**REGULAR MEETING OF THE
CITY OF CONCORD
DESIGN REVIEW BOARD**

**Thursday, October 27, 2016
5:30 p.m., Regular Meeting
GARDEN CONFERENCE ROOM
1950 Parkside Drive, Bldg. A**

SUBJECT: Staff Report Item No. 1 - Starbucks at 4290 Clayton Road Request for Exterior Modifications

Project Name: 1950 CONCORD AVENUE (PL160266 - DR)
Review Status: Final Design Review
Location: 1950 Concord Avenue
Parcel Number: APN 126-052-018
General Plan: Downtown Mixed Use
Zoning: DMX (Downtown Mixed Use)
Applicant: Sreenivas Ramireddy
1125 Trowbridge Way
Danville, CA 94506
(925) 351-4496

Issue Date: 08.07.14
Drawn By: DJE
Project Number: 1369
Sheet Title: Exterior Elevations

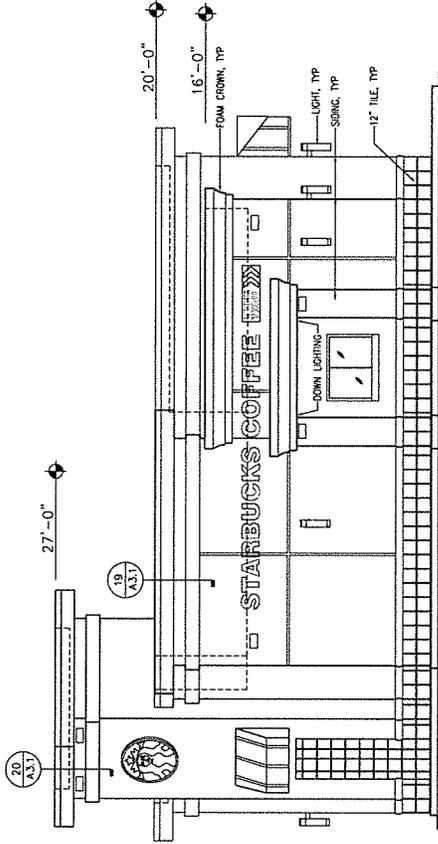
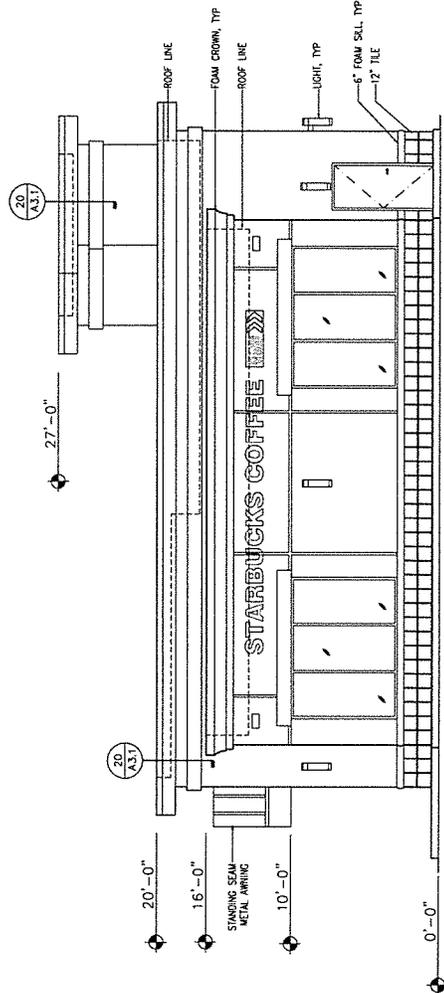
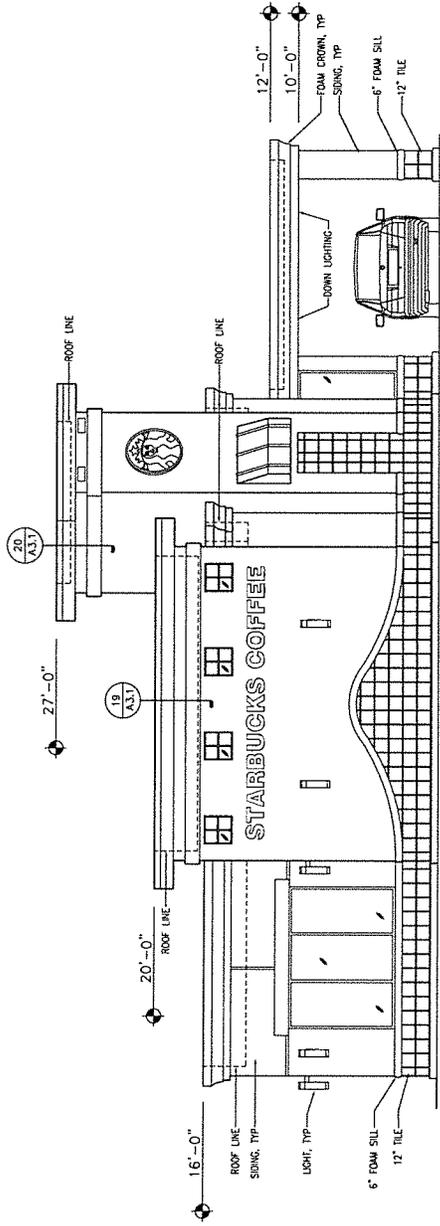
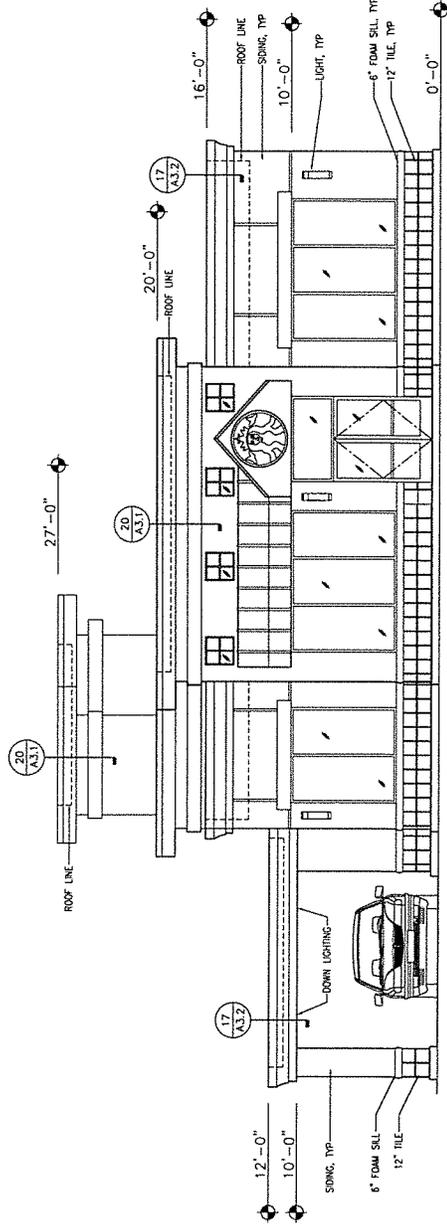
It was recently brought to staff's attention that downspouts were added to the exterior of the Starbucks building that were not shown on the approved Design Review plans. The downspouts were also not shown on the elevations for the building permit. The building permit roof plans do show parapet perforations for downspouts that are inconsistent with the building permit elevations. The downspouts were shown on tenant improvement plans for reference only.

Victor Chiang (project applicant and developer) requests modifying the approved Design Review plans and building permit to allow the downspouts. A letter from Mr. Chiang and David Elliot, project architect, explaining the situation and reason for this request are attached as Exhibits C and D, respectively.

Staff requests the Board provide one of the following regarding this matter: (1) a determination that the downspouts constitute a minor design modification, consistent with the intent of the approved plans, and a recommendation to approve the modification administratively, or (2) a recommendation on an alternate design solution to the downspouts for incorporation into revised building permit plans, or (3) a determination that the downspouts constitute a major design modification and a recommendation to the Planning Commission on a decision regarding the modification.

SOUTH ELEVATION
Building A
1/4" = 1'-0"

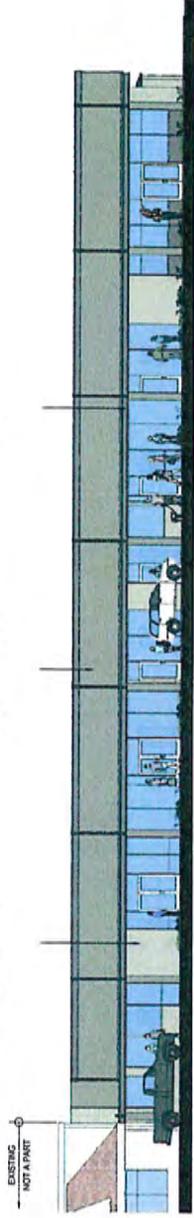
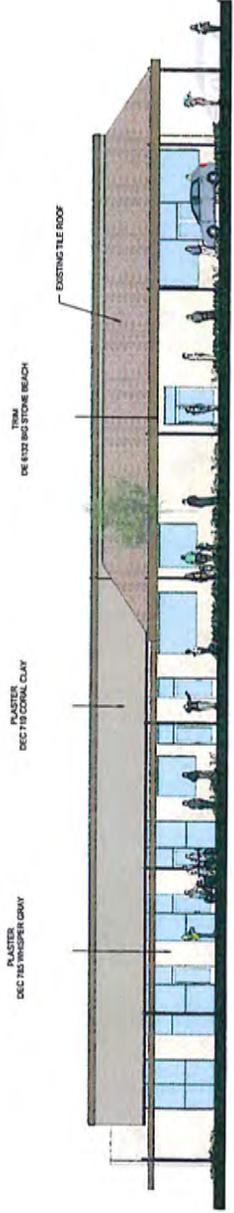
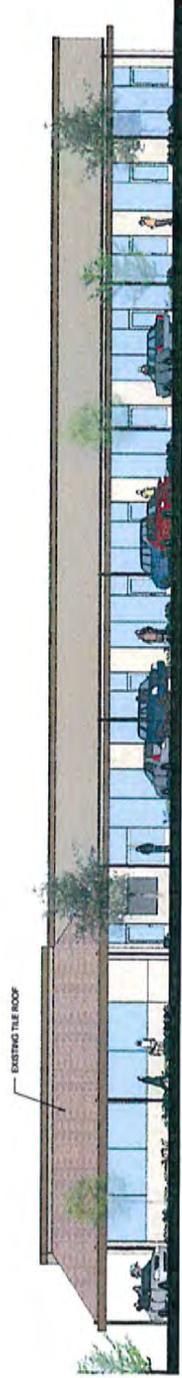
On October 13, 2016, the Board reviewed the color options proposed for re-painting the eastern portion of the Terminal Shopping Center. The Board continued this item and recommended the applicant provide a revised elevation that uses a combination of the tan and green color palettes proposed for Buildings A and B.

Staff recommends the Board review the revised color combination, determine if the revisions address the Board's comments, include a condition that "The doors on the back of the building shall be painted the same color as the body of the building" and approve the proposed colors.

On October 19, 2016, the applicant submitted revised colored renderings that utilize both the tan and green color palettes. Building A, located immediately adjacent to Big 5 Sporting Goods will be painted with the green color palette. Building B is proposed to be painted with the beige color palette. The use of both color schemes provides visual interest and addresses the Boards concern of providing distinction to the project site, while referencing the western portion of the shopping center where Big 5 and CVS are located.

Proposed First Floor Plan

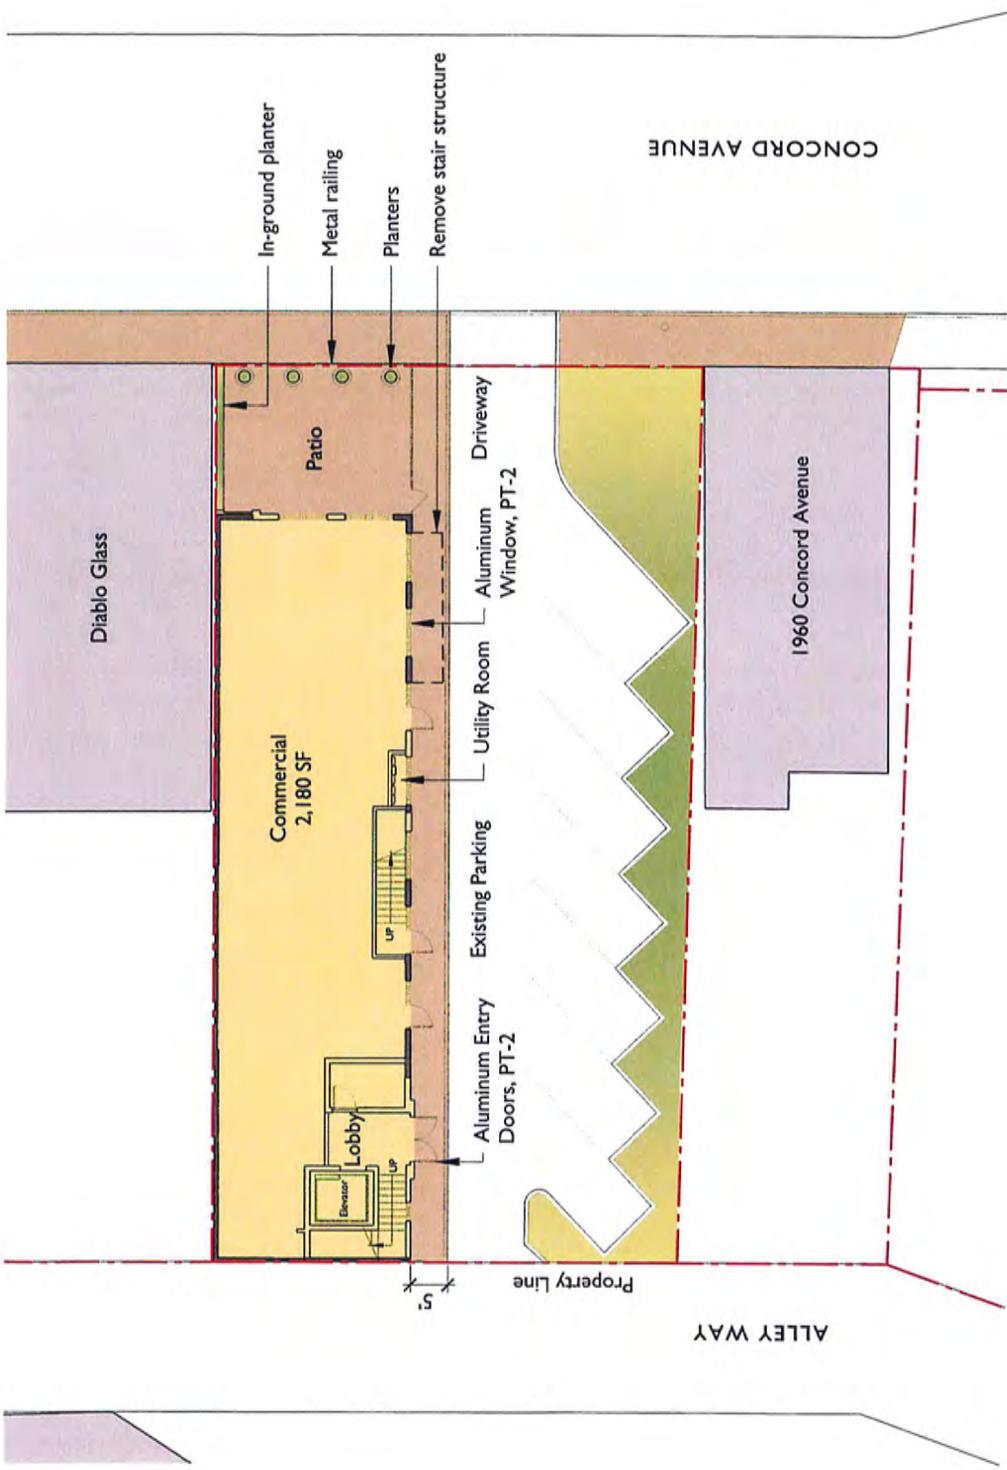
6. *Provide a landscape plan and consider enhancing the landscaping at the rear of the adjacent buildings.*

- Additional planting (vines, trellis) should be included to the degree possible adjacent to the existing building to the south (in parking area), to reduce potential for graffiti.
7. *Be mindful of where the utilities are placed as it may affect the final building design and consider locating the meters on the alley side of the building so they are not visible.*

A landscape plan has been provided showing planting within raised planters around the front patio area, within at-grade planters on either side of the driveway entry from Concord Avenue, and 3) at the rear of the site within planters on either side of the driveway exit.

Utility room has been included on the first floor of the southeast elevation for ease of access.

Proposed Southeast Elevation

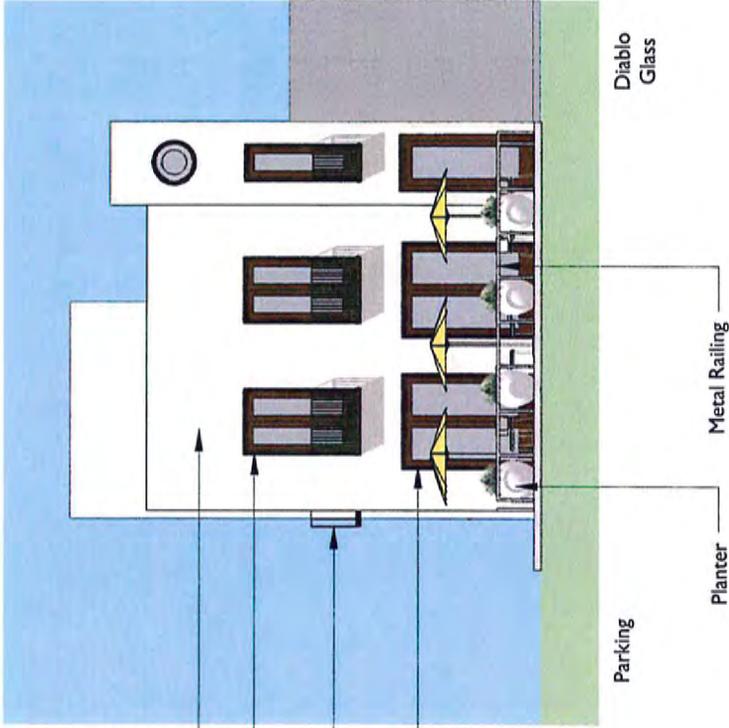
2. *Consider making the tower elements more decorative.*

- Adding a decorative feature such as an ornamental iron element, clock, window, or similar feature above windows on the entry tower on the southeast elevation.

4. *Consider eliminating some of the windows along the driveway elevation and introducing some massing to break up the building.*

5. *Consider introducing a shallow horizontal overhang along the driveway elevation (e.g., 2' projecting metal frame and glass awning).*

The revised elevations include more ornate railings for the balconies (detail on sheet A13), potted plants for use on the balconies at the front of the building as well as at the tower entry from the driveway, stucco recesses are now included on the upper southeast elevation of the building, and tenant signage guidelines have been included on Sheet A14 to indicate the type and location of potential signage that would be included.

The windows and additional design elements have been designed to establish a rhythm to the elevation and are important to the design. Instead, the additional design items mentioned items 2 and 3 have been incorporated to the design.

A 9-inch cornice has been provided at the top of the building. The cornice extends out from the roof approximately 8-9 inches. Details of the metal coping used and a detail of the section of the upper portion of the building have been included on Sheet A13. The cornice would be painted brown, consistent with the aluminum entry doors and window frames. Since we also need to have tenant signage, we increased the depth of the metal railing which will cast a deeper shadow and allow the necessary area needed for signage.

- Since the building has a small presence on the street, we view the southeast elevation to be an extension of the Concord Avenue elevation and the simple and bold rhythm is more eye-catching and impactful than breaking up the building volume.

- 5) *consider introducing a shallow horizontal overhang along the driveway elevation (e.g., 2’ projecting metal frame and glass awning)*
 - Since we also need to have tenant signage, we increased the depth of the metal railing which will cast a deeper shadow and allow the necessary area needed for signage.
